Norwell Solar Farm Steering Group

Road Solar and Biodiversity Park (GNR Project)– project ref. EN010162

Unique Number - [REDACTED] (Our ref NSG/7)

**Deadline 3. Response to Additional Information Provided by the
Applicant.**

Plate 1

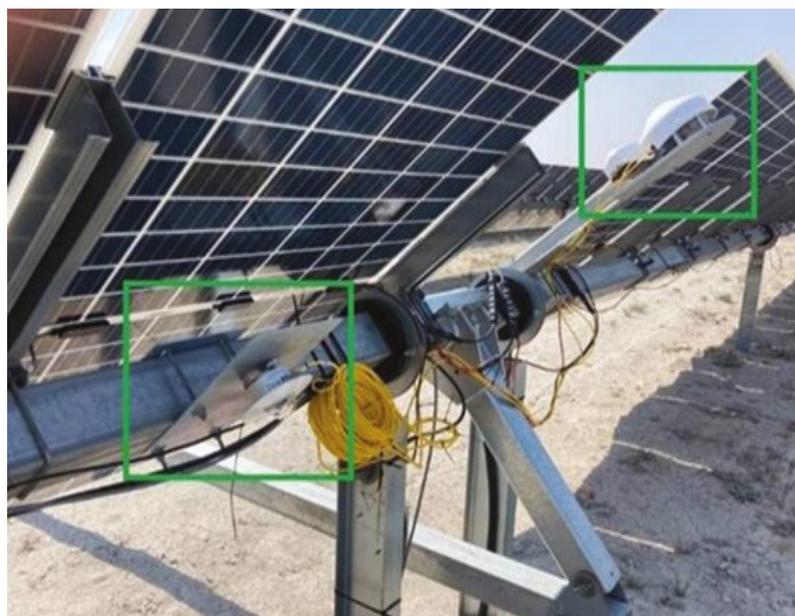
- 3.5 There are a range of studies examining this question. However, perhaps the most relevant is a real world assessment in "A comparative study of bifacial versus monofacial PV systems at the UK's largest solar plant" Badran and Dhimish (2024) Clean Energy Volume 8 Issues 4.Oxford University Press⁵ Over 4 years,the comparative performance and degradation of monofacial and bifacial panels was measured on the same solar farm near York. It concluded that the bifacial panels outperformed by a factor 15.12-17.31%. However it also found that the bifacials had a marginally higher degradation rate of 1.17% per annum. One of the reasons this generation gain might be higher than other studies is shown in the image below:

- 3.6 It can be seen that the ground conditions for many of the bifacial modules have been cleared of grass, leaving a far more light reflective surface. The Great North Road ground surfaces will absorb more and reflect less energy as they will be grass pastures (required for the sheep). The Applicant in our Statement of Common Ground has quoted an acceptable albedo for the grass of 0.2. Given all these findings, it seems fair that the capacity factor of 10.5% previously adopted by the Group should be increased by 15% to 12.07%. The degradation rate will not be as high as in York due to less reflectivity but a generous 0.7% rate will be now adopted. These parameters will now be used to recalculate all predicted generation figures. It does alter the maximum theoretical annual generation :-

Plate 2

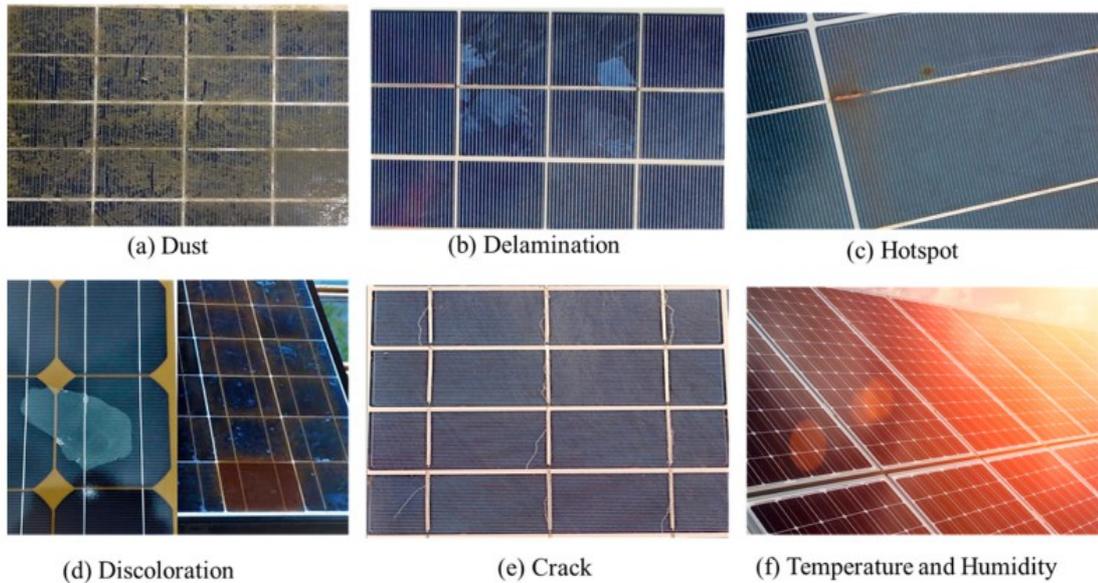
- 5.2.6 One excellent published academic review -*"Investigation of Degradation of Solar Photovoltaics: A Review of Aging Factors, Impacts, and Future Directions toward Sustainable Energy Management"* Rahman et al (2023) University of Bangladesh⁷ – provides a comprehensive explanation as to how panels degrade and at what rate. The study includes the following imagery showing visible key ageing factors.

5.2.7 The findings of this study are very detailed and here is probably not the right place to explain them in any detail. Appendix D has extracts from the report though the full picture is only really seen when the report is read in full.

Figure 1

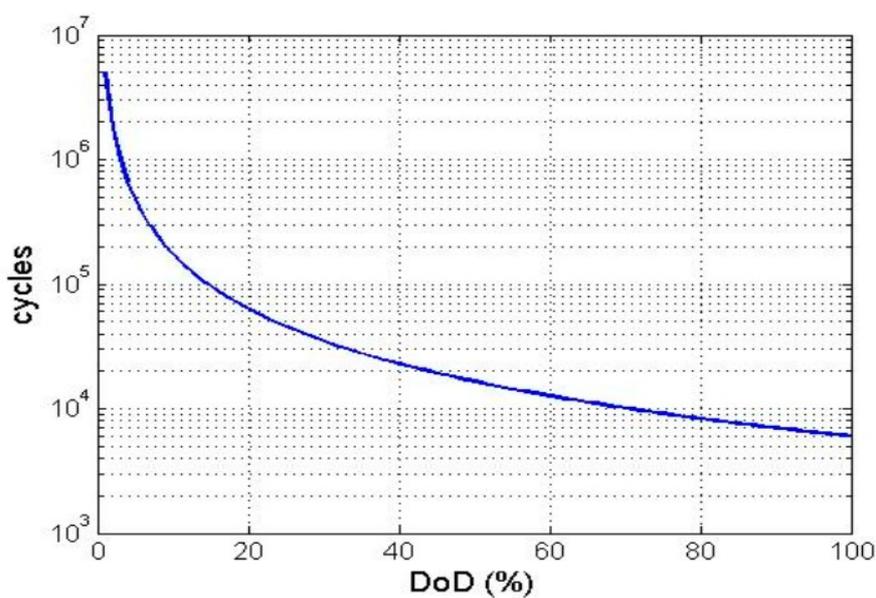
- 6.4 Included here also is a reference to "A PSO-Optimized Fuzzy Logic Control-Based Charging Method for Individual Household Battery Storage Systems within a Community. Cheng et al (2018)⁹. This study is useful as it goes into far more detail about the science leading to the degradation of these cells. It does of course concentrate on domestic batteries but the science is the same. It also provides a helpful graph as below:

Figure 2

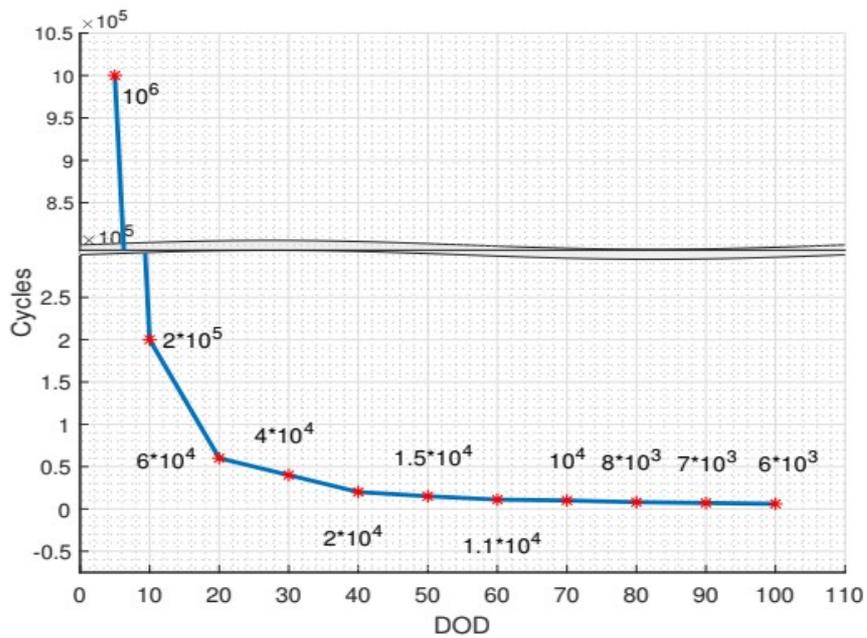
- 6.5 Whereas the above study principally looks at domestic cells, the following addresses the same issues but for utility scale energy storage systems. "A Review on the Degradation Implementation for the Operation of Battery Energy Storage Systems" Garcia-Miguel et al, 2022 University of Madrid.¹⁰ This publication repeats much of the science but applies it to a BESS. It produces similar findings, represented by the graph below:

- 6.6 If need be, more studies and journals can be cited, all of which describe the reduction in achievable cycles brought about by increasing the DoD.

Figure 3

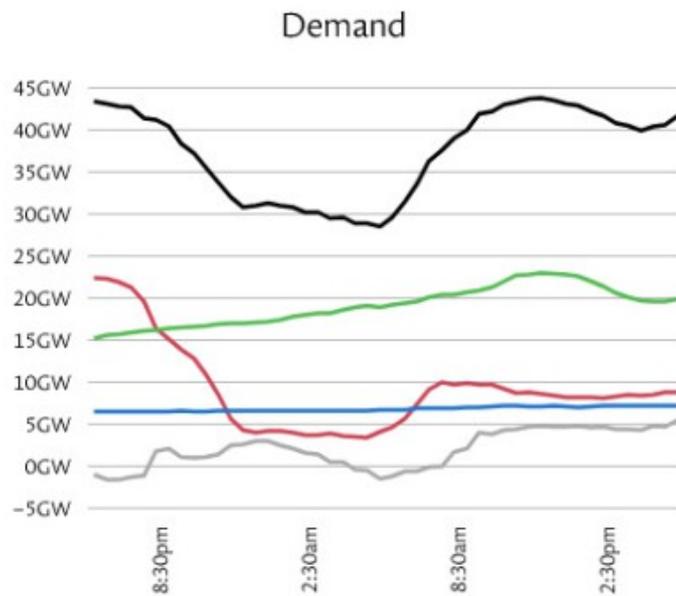
- 6.8 The Group's position has always been that the BESS will charge overnight from the grid. After all, the principal justification for this infrastructure is to balance out grid supply. Given that there may be a handful of days each when charging cannot occur (possibly because of maintenance or component replacement issues), it would be fair to assume at least that the grid charging will occur 355 nights a year.

- 6.9 The above graphic, drawing on data from the National Grid showing demand overnight and into the day (30/01/26, from website grid.iamkate.com accessed 30/01/26), demonstrates the speed in the increase in demand for the morning peak and hence the need for increased generation and supply from storage.
